Project: Great Wolf Lodge, Chesterton  
Prepared by: Kathryn Lewis/ David Lewis  
Approved by: Phil Bell  
Date: 04/09/2020

**GREAT WOLF RESORT, BICESTER - STAGE 1 RSA IN RESPECT OF JUNCTION IMPROVEMENT AT MIDDLETON STONEY**

Proposed Junction Improvement at Middleton Stoney

Document: Stage 1 Road Safety Audit

Drawing 1803047-17

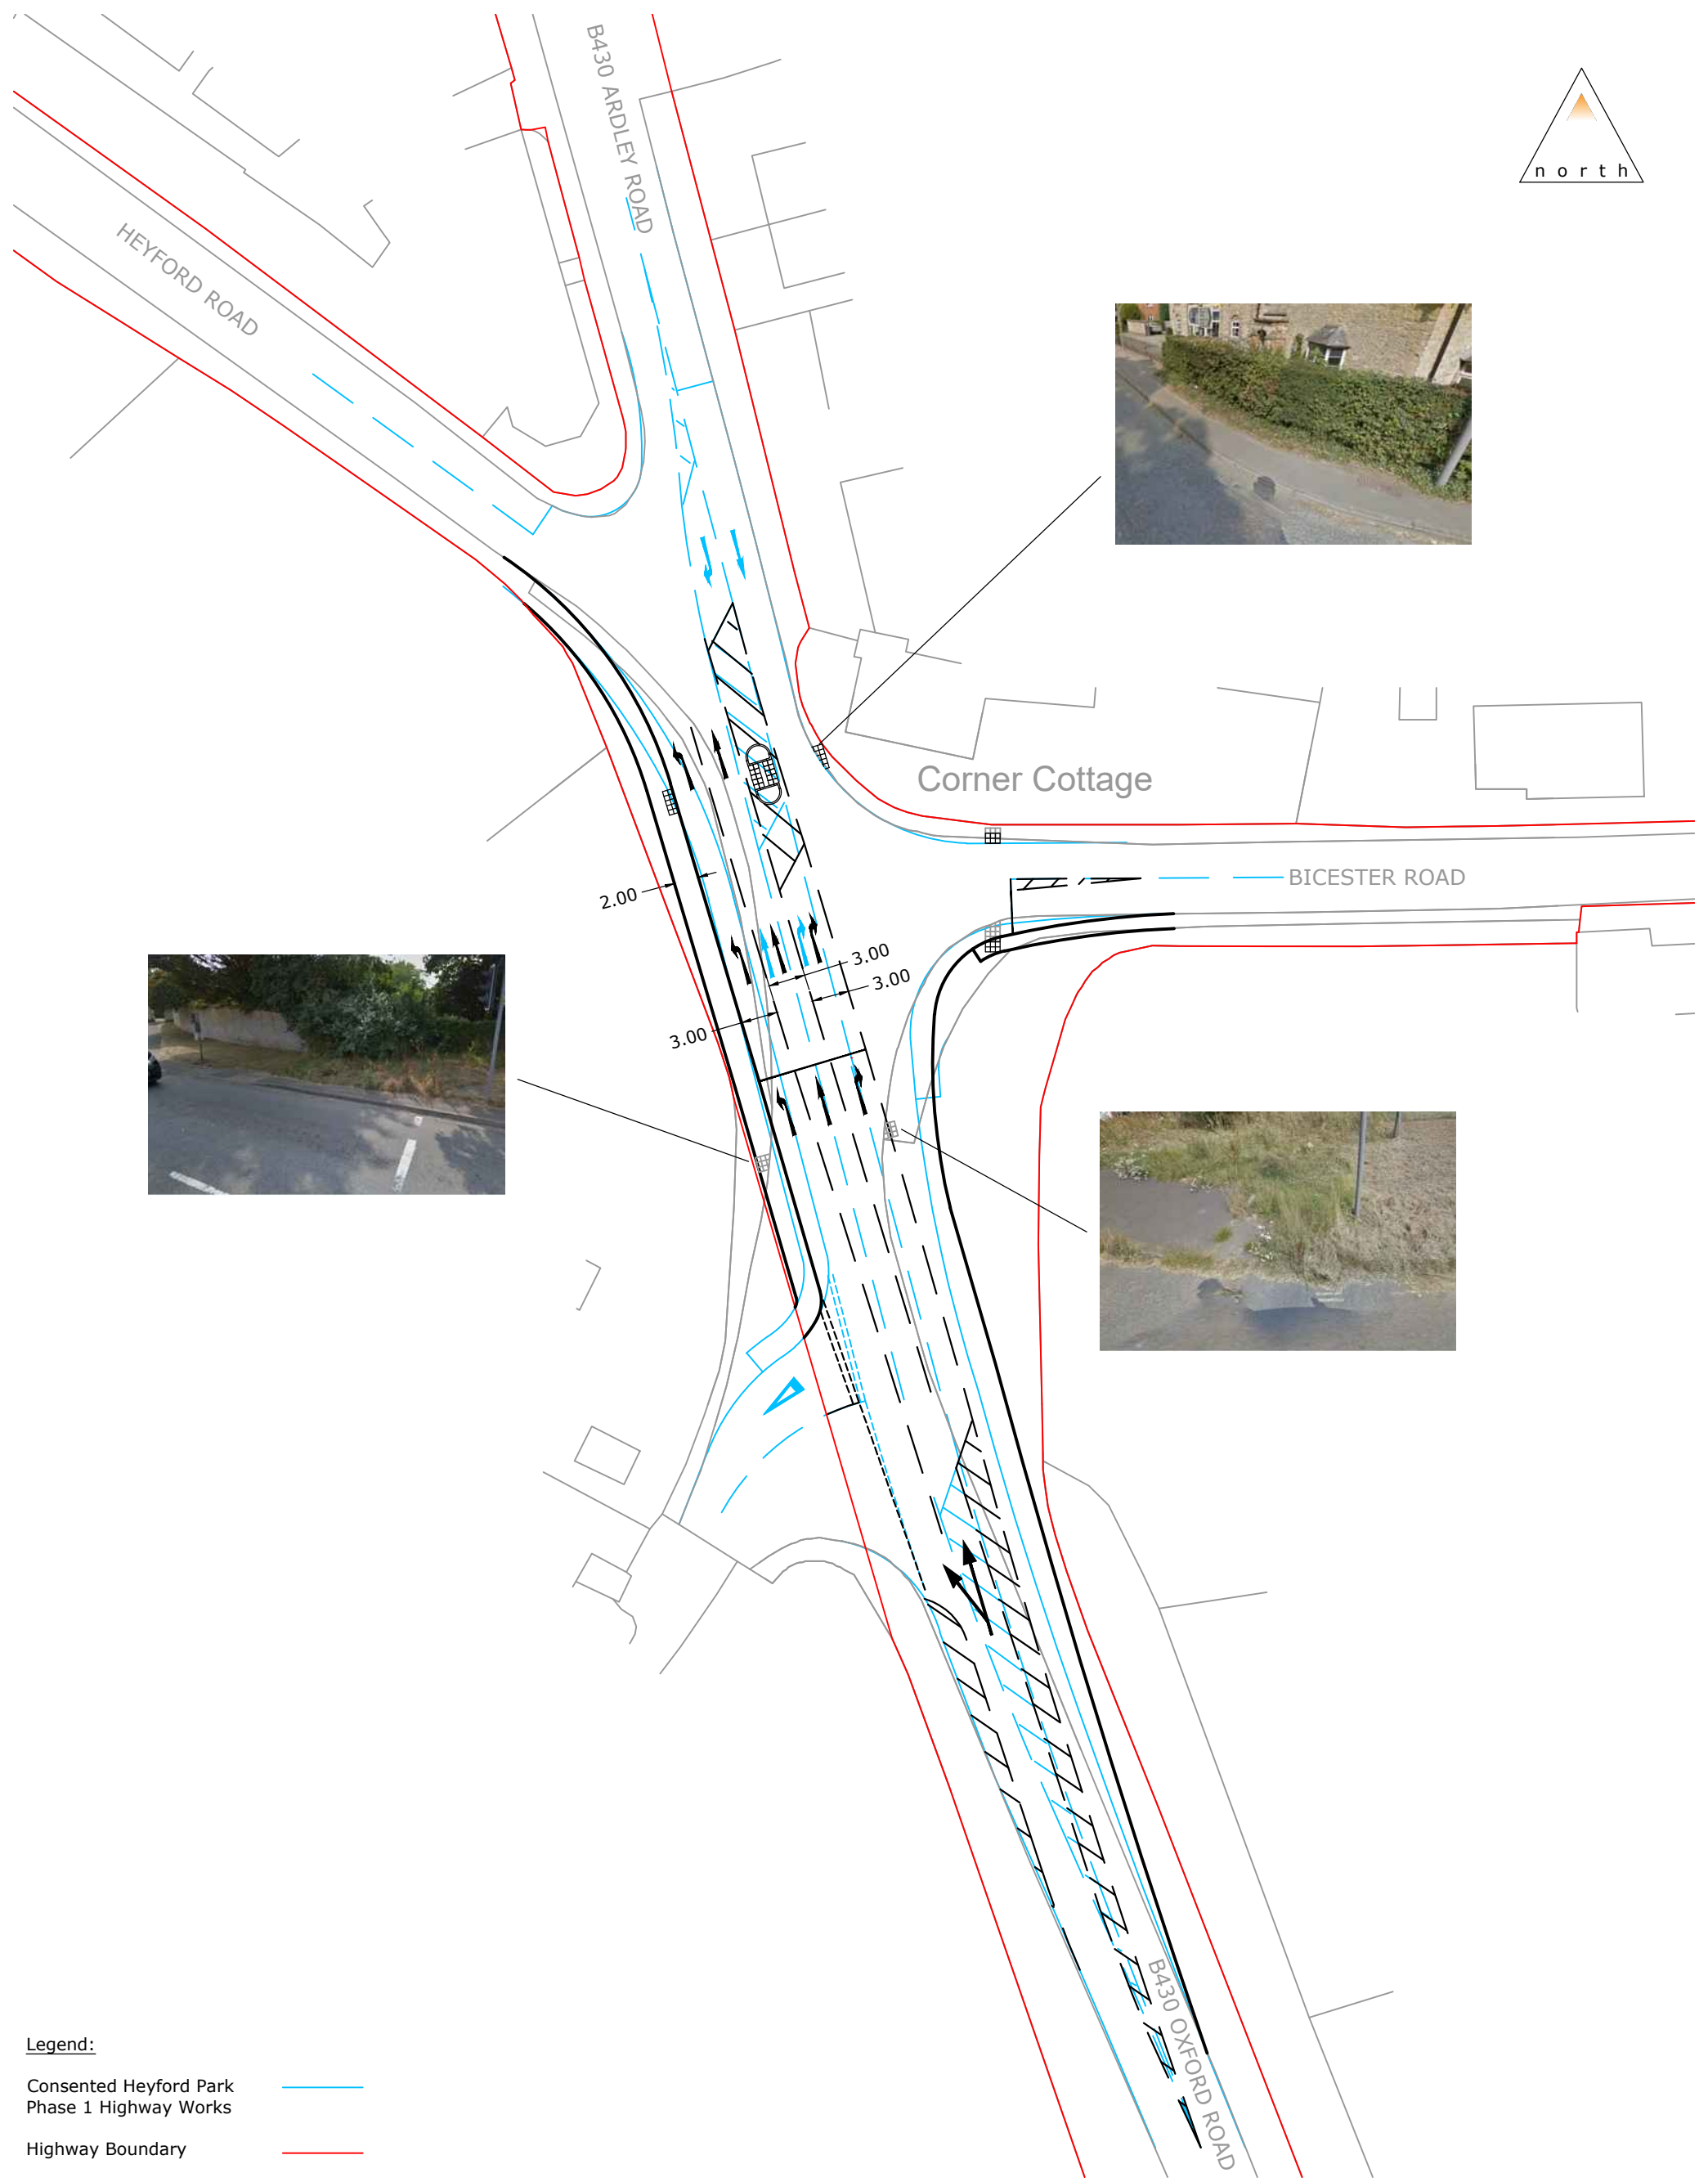
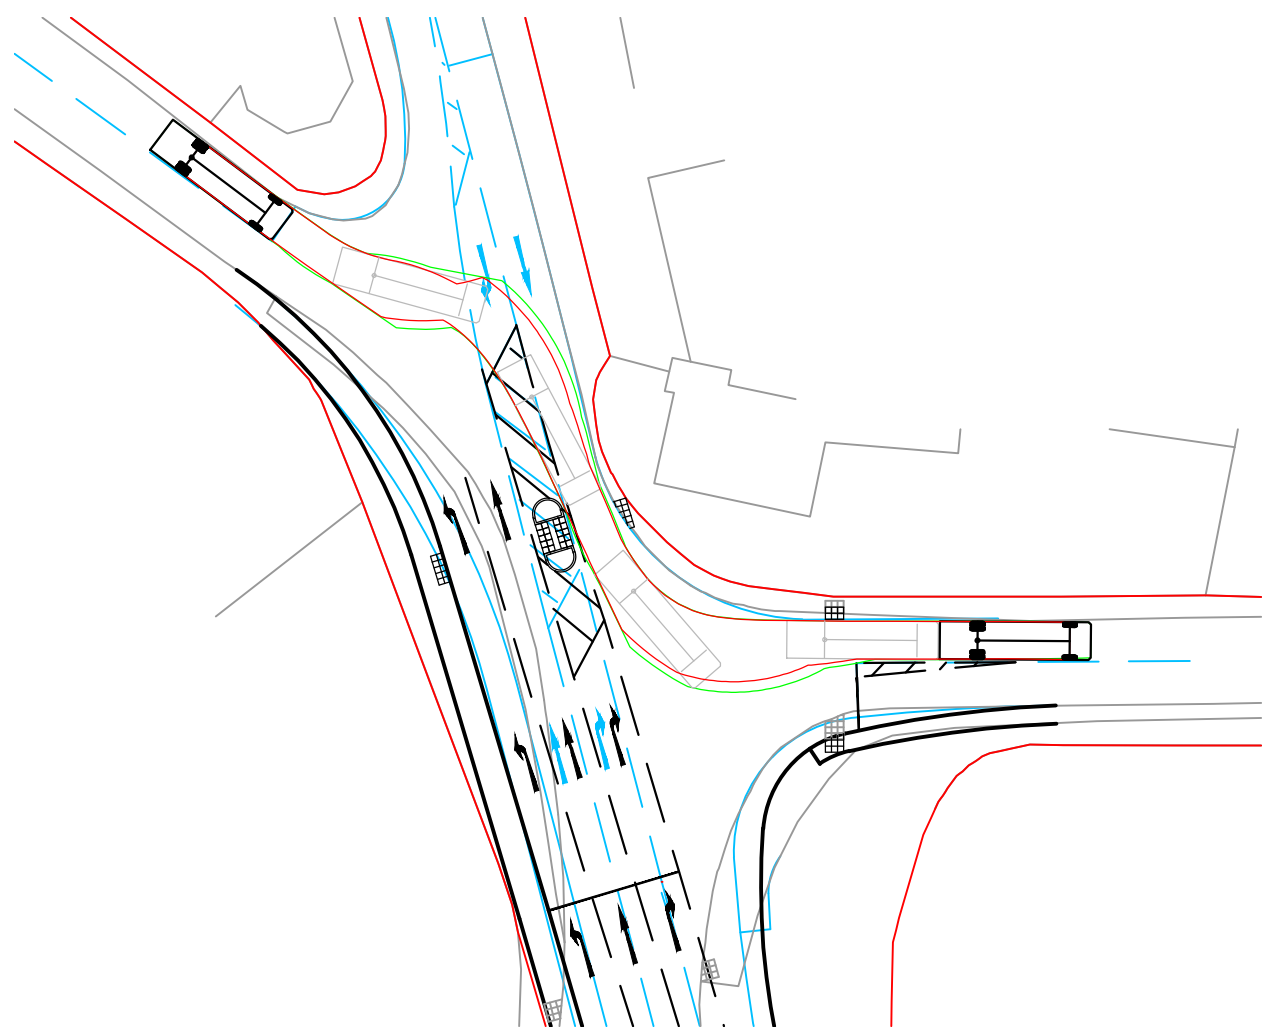
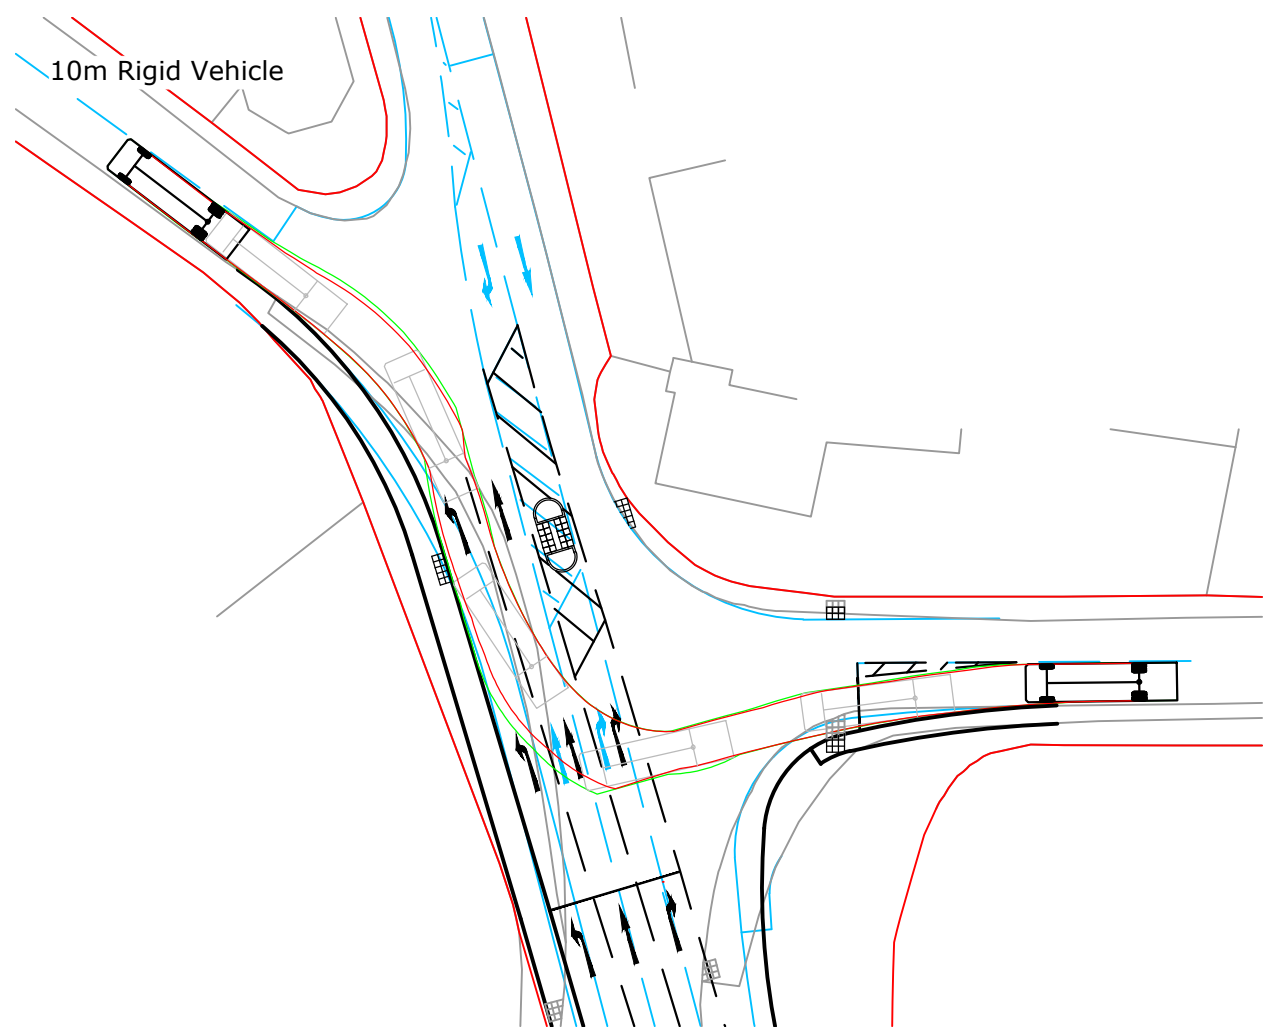
- 3.12 It is noted that OCC provided some commentary on a previous iteration of the proposed highway mitigation works in email correspondence dated 10<sup>th</sup> March 2020. In response to those comments from OCC the proposed highway mitigation scheme has been updated and the following commentary is provided:

- ▶ OCC queried whether it is likely that all vehicles routing north will switch to the central ahead lane in advance of the stopline and some northbound traffic may remain in the nearside left turn lane and this could result in vehicles merging after the stopline. The mitigation works include changes to the road markings in advance of the northbound stopline. The amended road markings mean that the straight-ahead northbound lane is a continuous lane with the new turning lane towards the B4030 west filtering to the left. Vehicles continuing northbound on the B430 will not be required to change lanes and only the turning traffic (left and right) will be required to switch into the respective turning lanes. On that basis it is considered that the majority of vehicles will be utilising the correct lane at the stopline and it is unlikely that vehicles will be required to merge or change lanes after the stopline. Furthermore, it is considered that signage in the form of dedicated lane advance direction signs (as set out at Section 6 of Traffic Signs Manual Chapter 7) can be installed in advance of the junction to advise drivers the appropriate lane at the stopline and detail of signage will be provided at the detailed design stage;

- ▶ OCC noted that queuing vehicles in the northbound straight-ahead lane could block vehicles entering the proposed new left turn lane. In response, it is highlighted that the junction capacity modelling has been undertaken using LinSig and this assesses the utilisation of the proposed flared left turn lane based on the proposed dimensions and adjusts the utilisation of that lane based on expected queuing in the central lane and the potential for queuing to block access to the left turn filter lane. On that basis, the junction modelling presented in this Note reflects the proposed layout and the likely utilisation of both ahead and the new left turning lane;

The footway width at this location is presently reduced by verge overgrowth and, to a lesser extent, the boundary hedge. Pedestrians waiting to cross would therefore necessarily stand close to the kerb, potentially leaving them vulnerable to a collision with a passing vehicle.

Northbound drivers approaching the junction may not be aware of the lane assignment and could make late lane changes, leading to side impact collisions.

Drivers turning right into Middleton Park may inadvertently stray into the right turn lane for Bicester Road, leading to heads-on collisions.

Drivers emerging from the private access may not know which traffic stream has priority (a green signal) and could collide with a vehicle passing through the junction.

Cut back the verge overgrowth at the back of footway on the east side of Ardley Road, particularly at the proposed uncontrolled crossing. Also trim back the boundary hedge within the highway as far as possible.

Provide a lane designation/destination sign on the northbound approach to the junction.

On Oxford Road, provide additional road markings (e.g. arrows) and/or road studs between the southbound lane and the right turn lane to enhance legibility of road layout.

Provide a traffic signal head on the proposed pedestrian refuge, facing Ardley Road (southbound) but also visible to the drivers emerging from the private access.

5.1	n/a			
5.2	n/a			
5.3	Cut back the verge overgrowth at the back of footway on the east side of Ardley Road, particularly at the proposed uncontrolled crossing. Also trim back the boundary hedge within the highway.	The footway width is unchanged as part of the proposed highway works, but opportunity to cut back overgrowth and boundary hedges to improve clear footway width can be reviewed at the detailed design stage.

5.4	Provide a lane designation/destination sign on the northbound approach to the junction.	Lane designation signage can be provided on approach to the junction and this can be included at the detailed design stage.

Drawing: **1803047-TK62** Revision: -

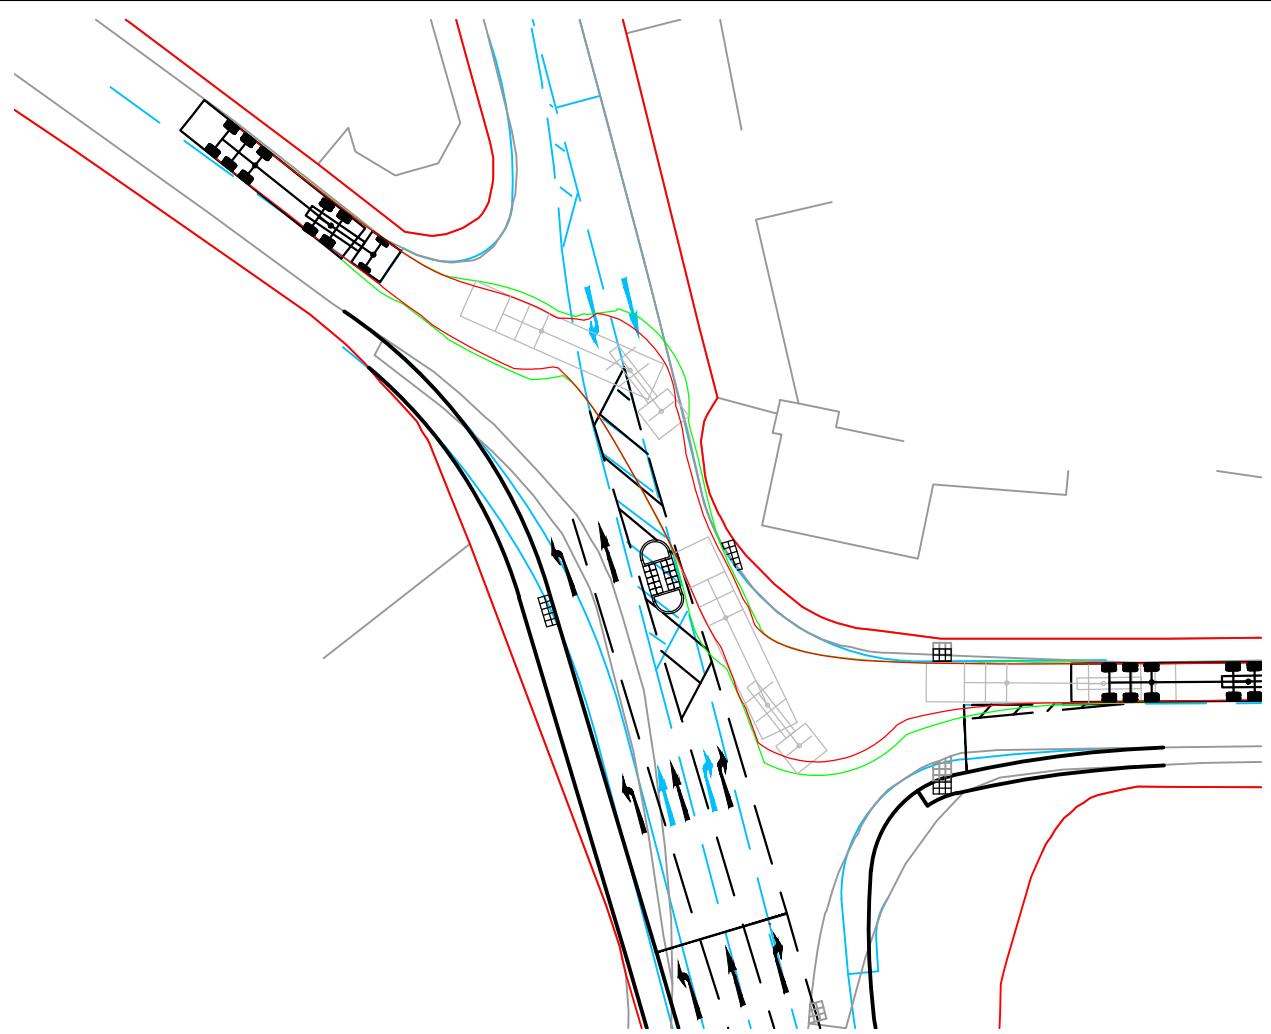
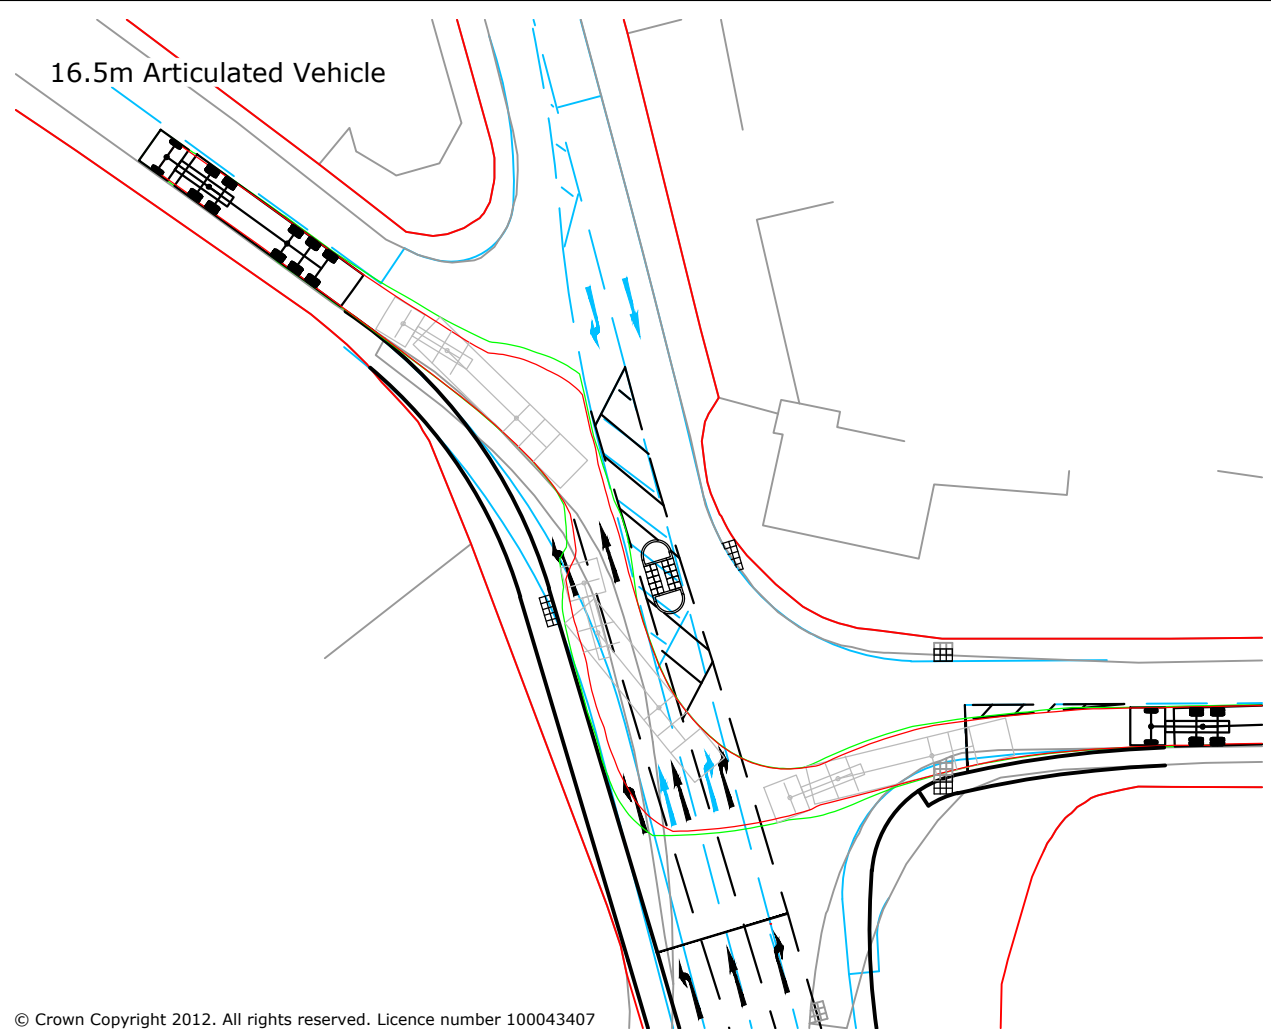
- ▶ As requested by OCC, swept path analysis has been undertaken for HGVs and articulated vehicles routing from the B430 east to west and *vice versa* and this is shown at Drawing 1803047-TK62, attached at [Appendix B](#). The swept path analysis demonstrates that a 10 metre rigid vehicle and 16.5 metre articulated vehicle can manoeuvre appropriately from the B430 east to the B430 west and *vice versa* and will not conflict with the proposed pedestrian refuge; and,
